ADDENDUM NO. 2

PROJECT NAME: Center for Brain, Biology and Behavior

UNL PROJECT NUMBER: C049P137

DATE OF ISSUANCE: July 17, 2012

1 **REVISED ENLARGED RESTROOM PLAN - CONCOURSE LEVEL**
 SCALE: 1/4" = 1'-0"

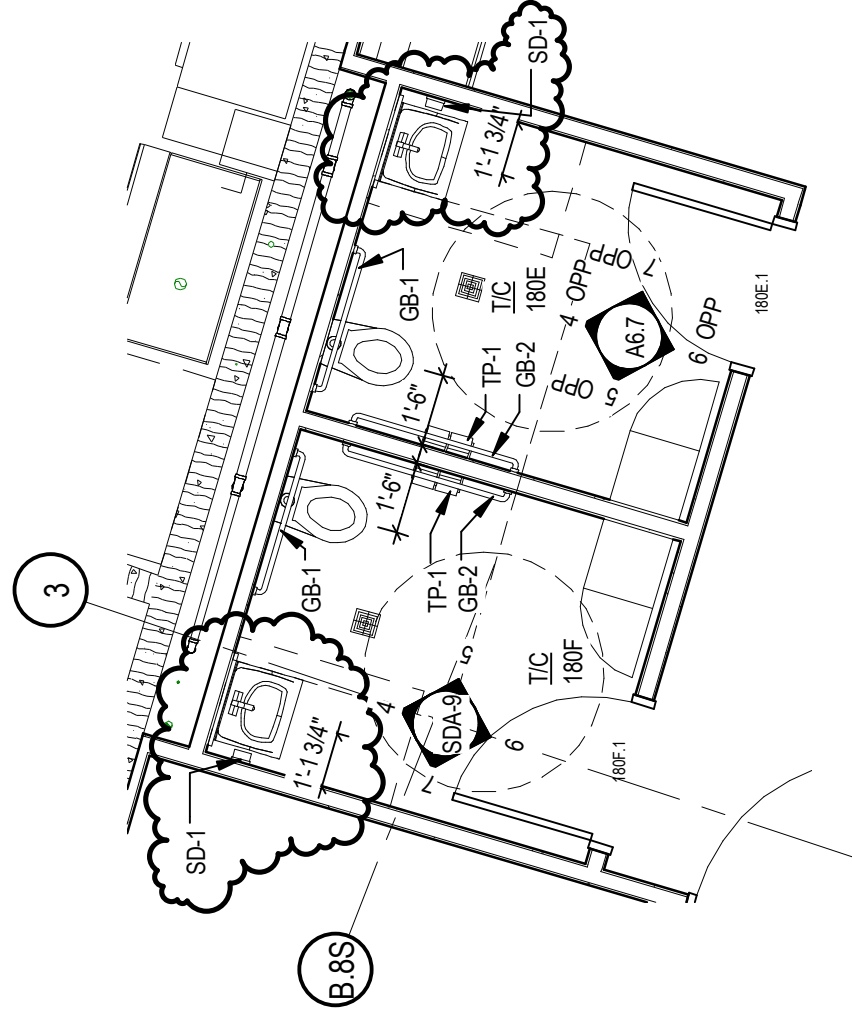
Item 2-30: Sheet A6.7 – ENLARGED RESTROOM PLANS AND INTERIOR ELEVATIONS

Refer to detail 1 – ENLARGED RESTROOM PLAN – CONCOURSE LEVEL. Relocate wall hung lavs to ensure ADA clear floor clearances as indicated in attached supplemental drawing SDA-9, dated July 17, 2012.
